## **ADDENDUM NO. 1**

### **TO SPECIFICATIONS AND PLANS FOR THE CITY OF TRAVERSE CITY**

#### **WEST END BEACH PARKING LOT REPAIR AND MDNR GRANT #TF22-0162 BATHROOMS PROJECT**

ISSUED: February 13, 2025

Revision/Issue	Date
REVIEW	7-30-24
ADDENDUM #1	2-13-25
Date:	2025-01-21
Project No.:	2024-003
Drawn by:	JAS
Scale:	1" = 20'
Sheet No.:	5 OF 9

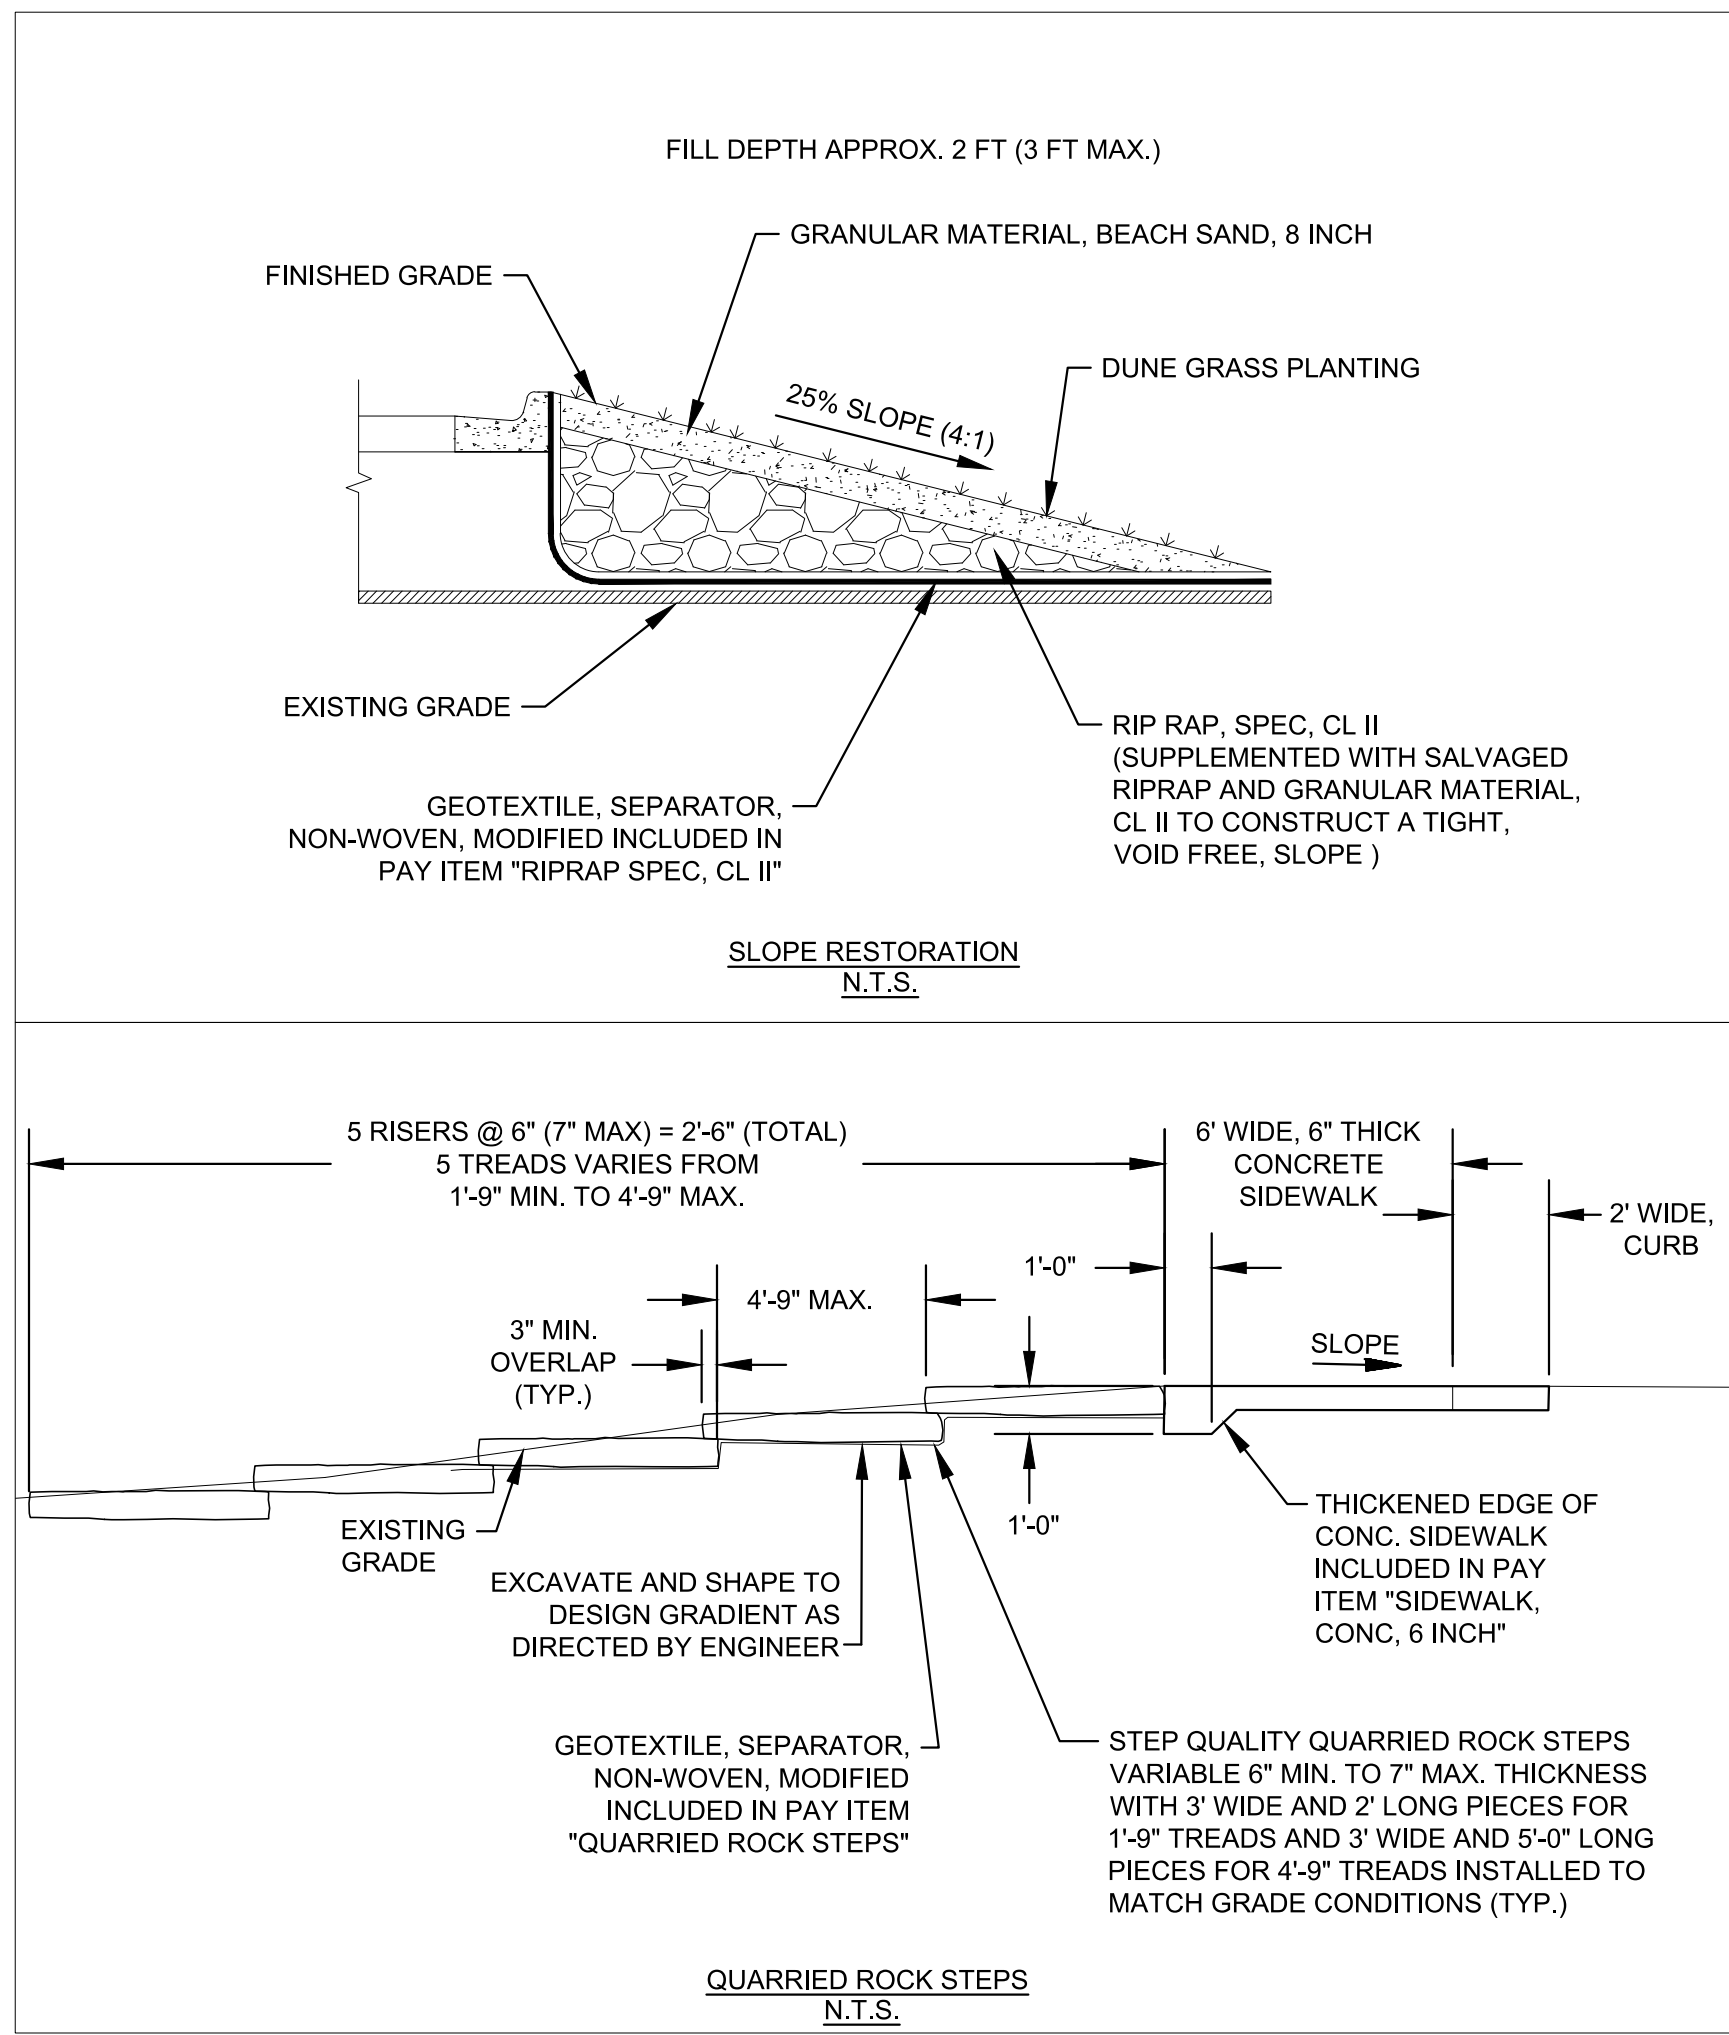
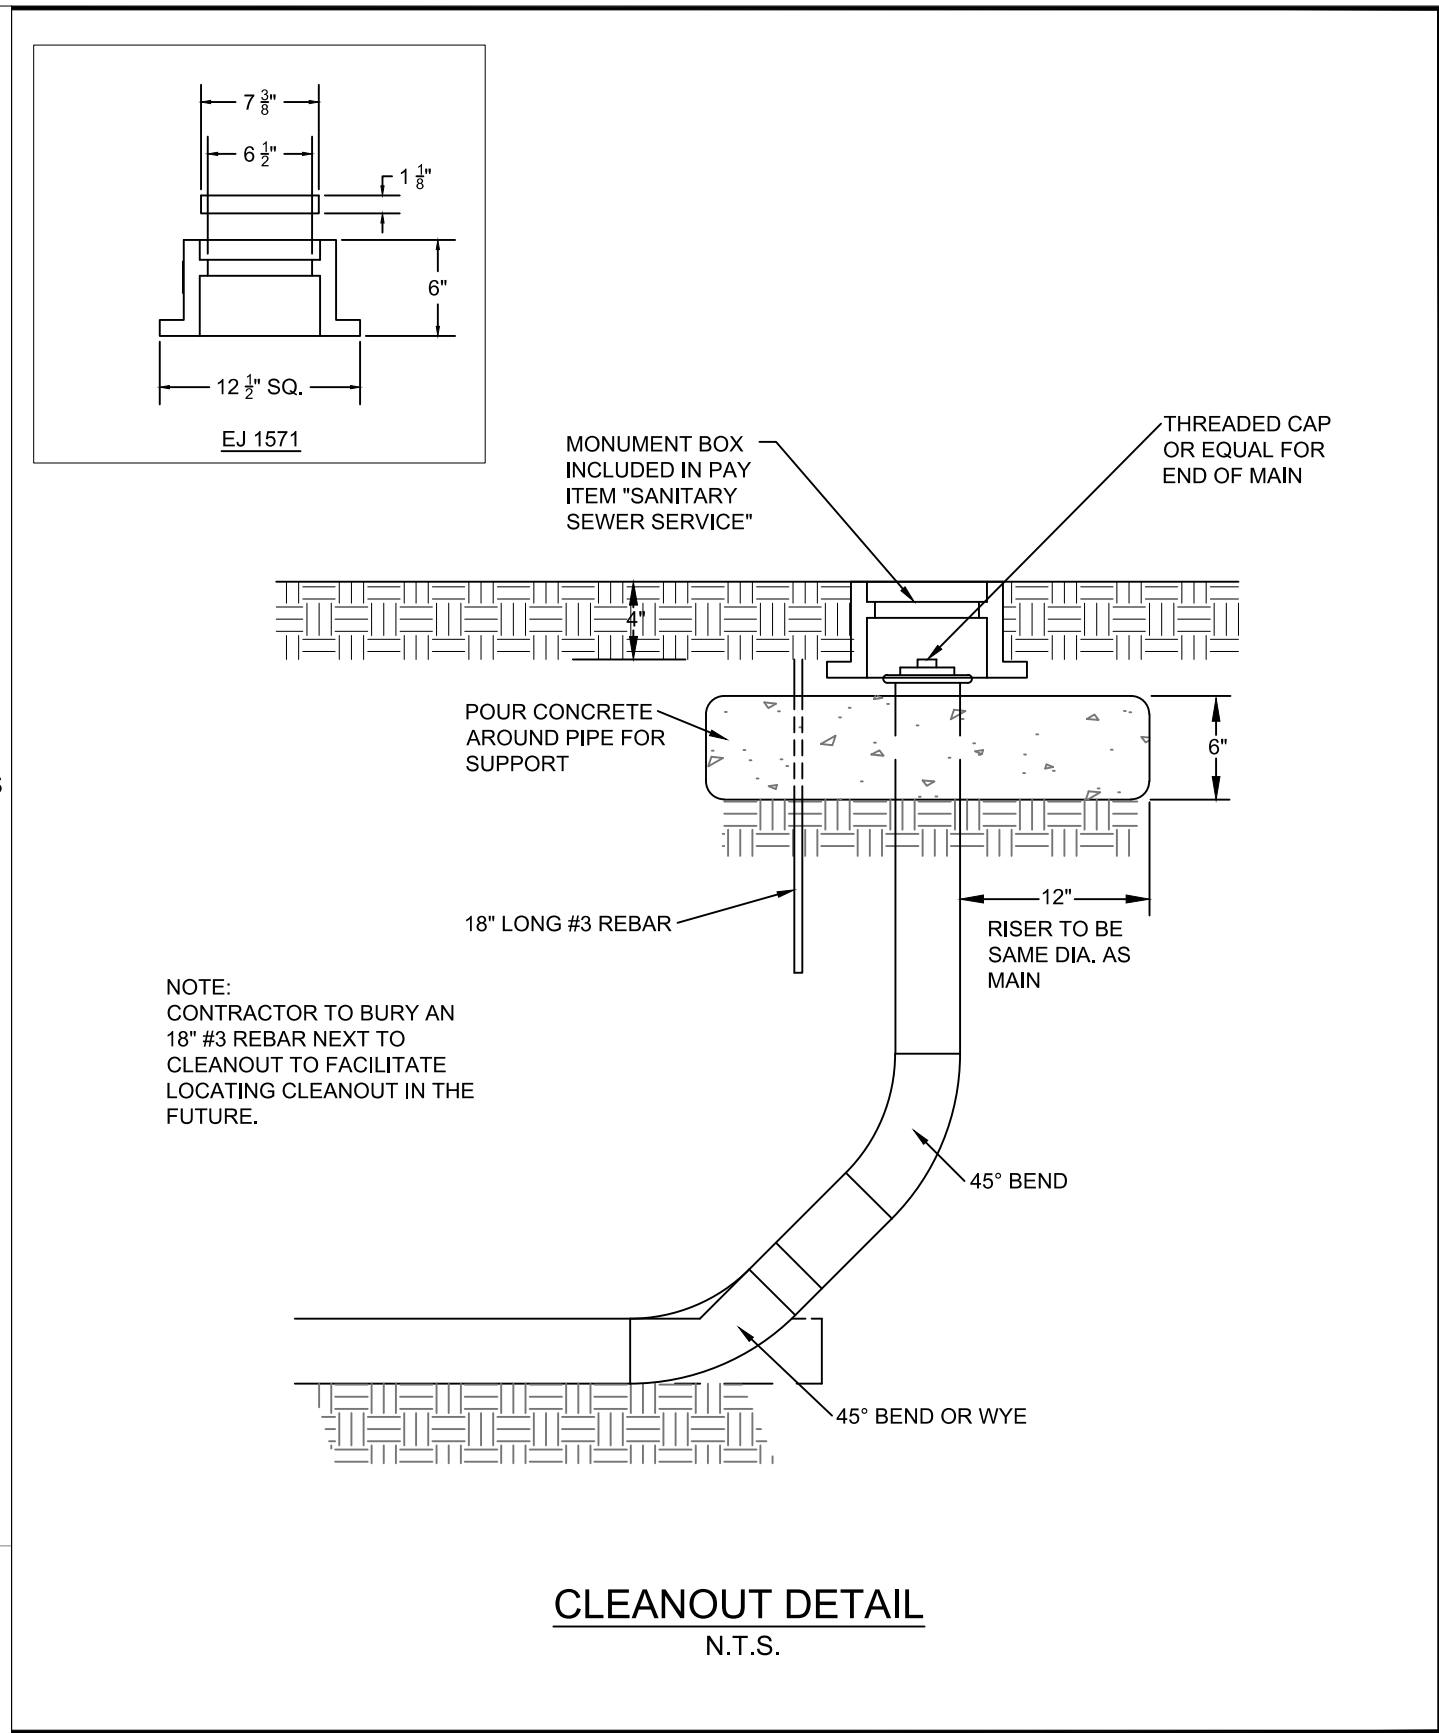
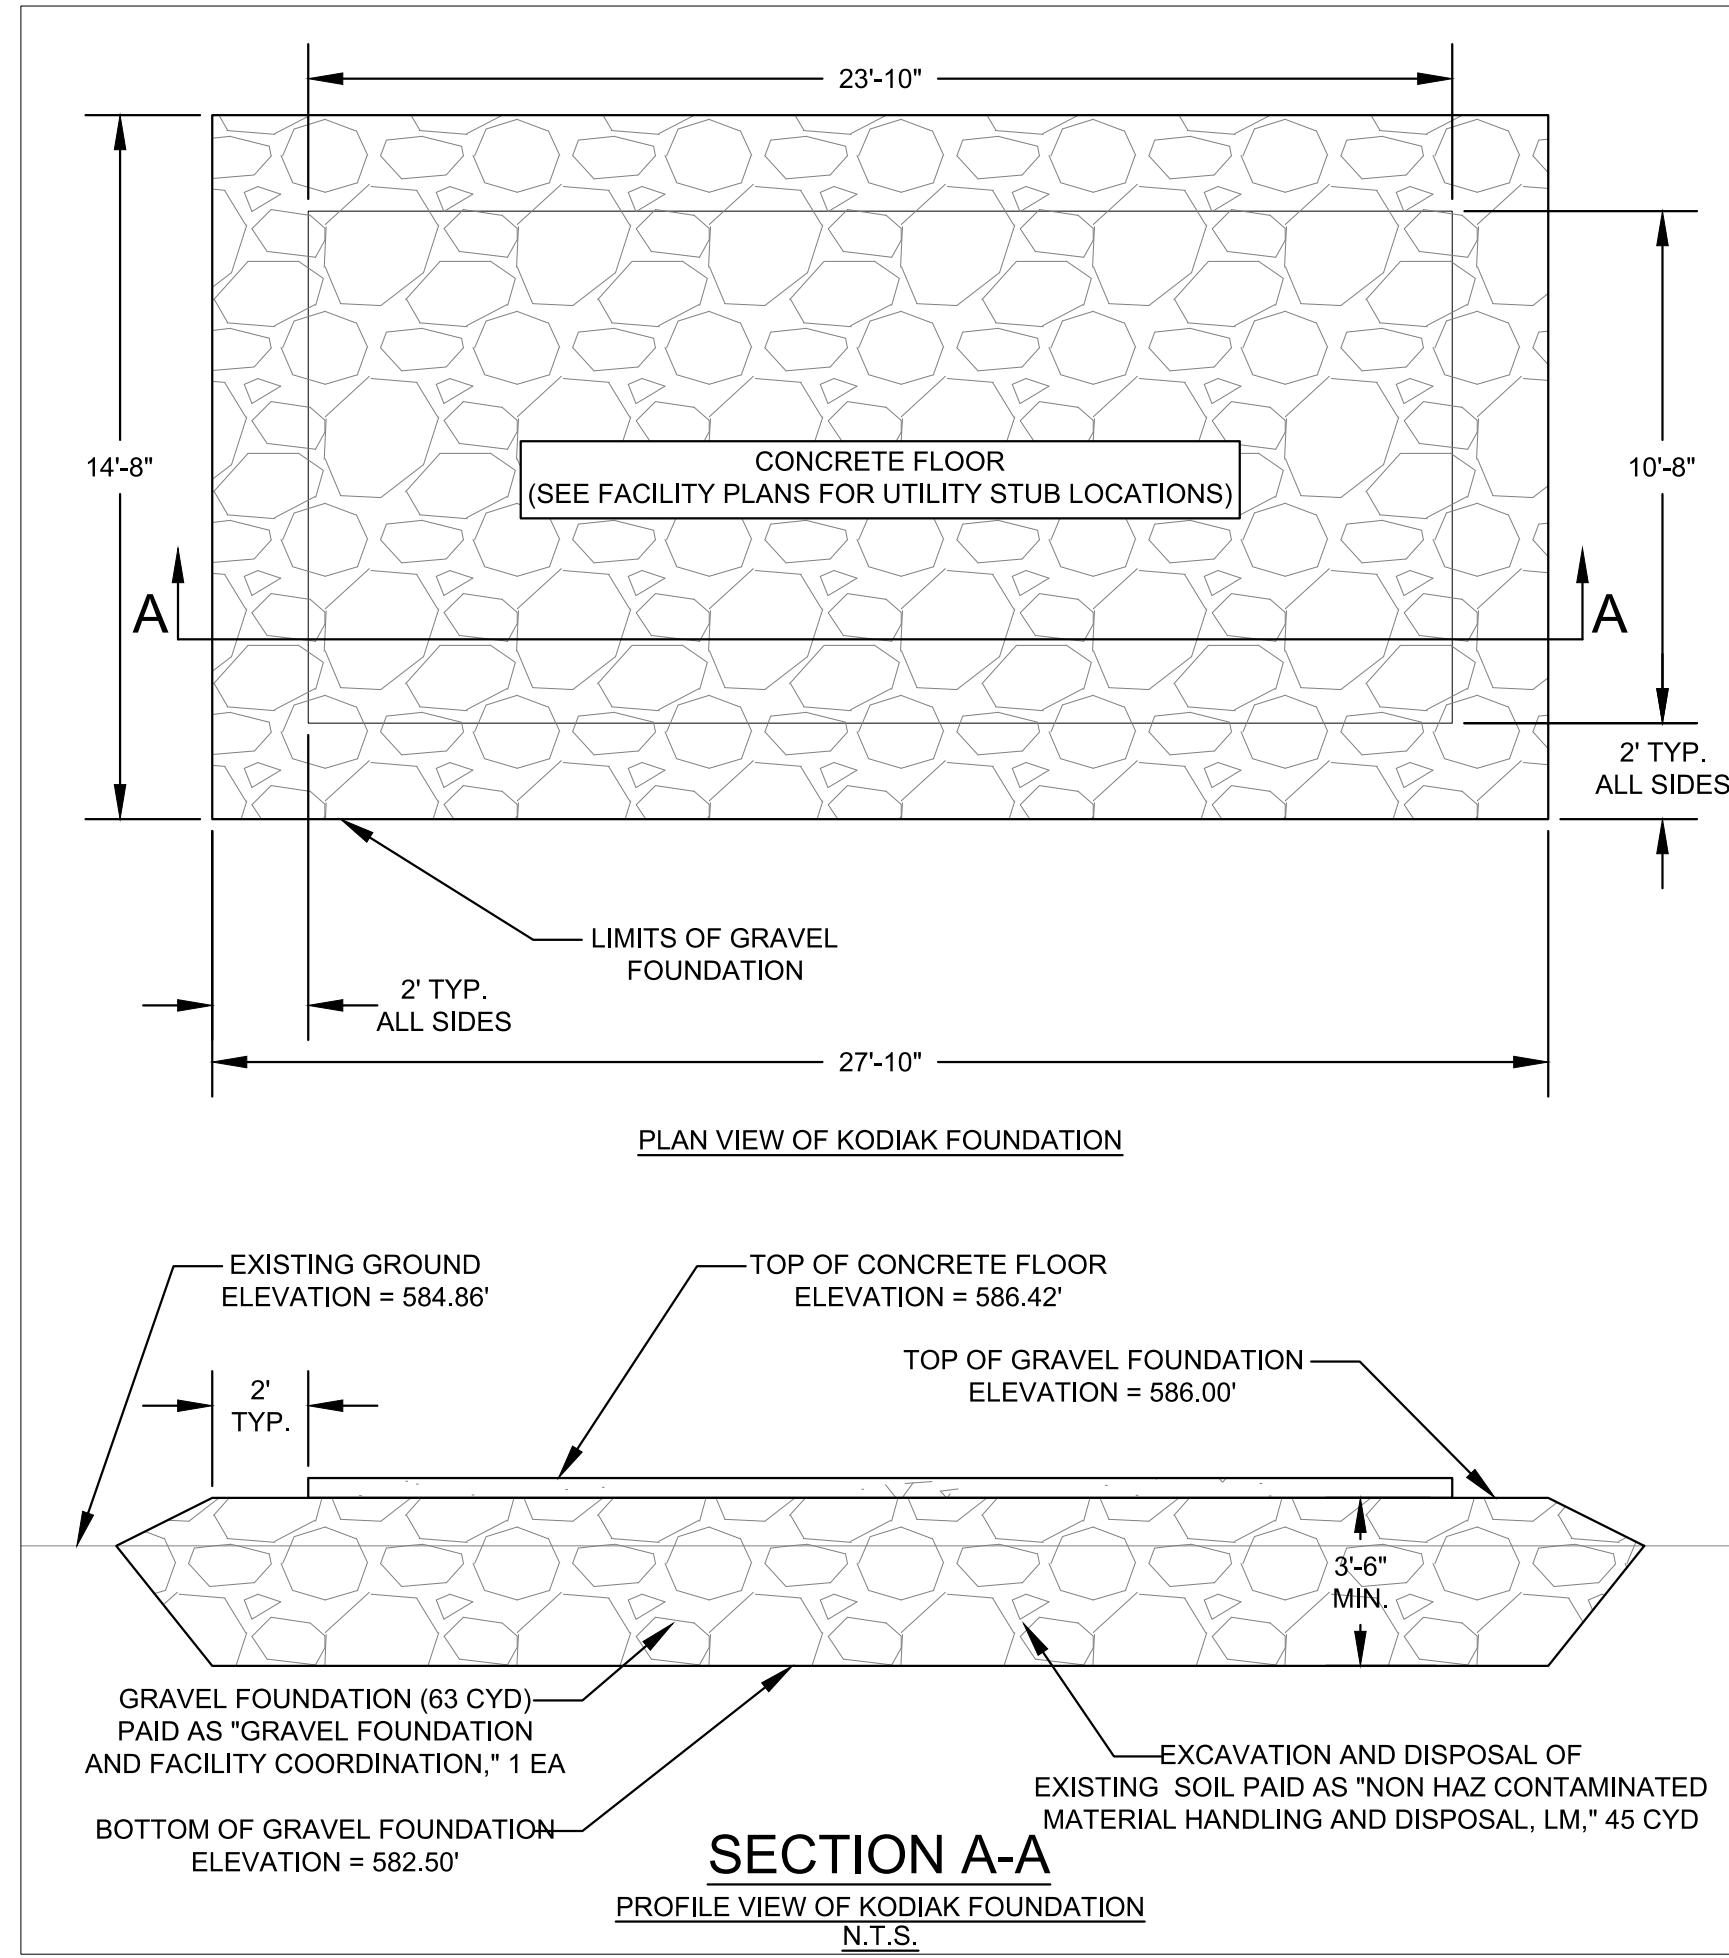
1. Sheet 3
  - a. Added Granular Material, CI II to slope restoration area.
  - b. Casting symbol at CB-3266 location has been removed.
  - c. Added note clarifying extents of thickened edge sidewalk.
2. Sheet 5
  - a. Added Granular Material, CI II to slope restoration detail. The sand will be used to supplement the riprap to provide a void free (as much a practical) slope.
  - b. Called out Geotextile, Separator, Non-Woven, Modified material under the Quarried Rock Steps in the detail.

1. Added the attached special provision for Geotextile, Separator, Non-Woven, Modified (01-13-2025) to the project specifications. This material must be used as shown in the Slope Restoration and Quarried Rock Steps details and will not be paid for separately.
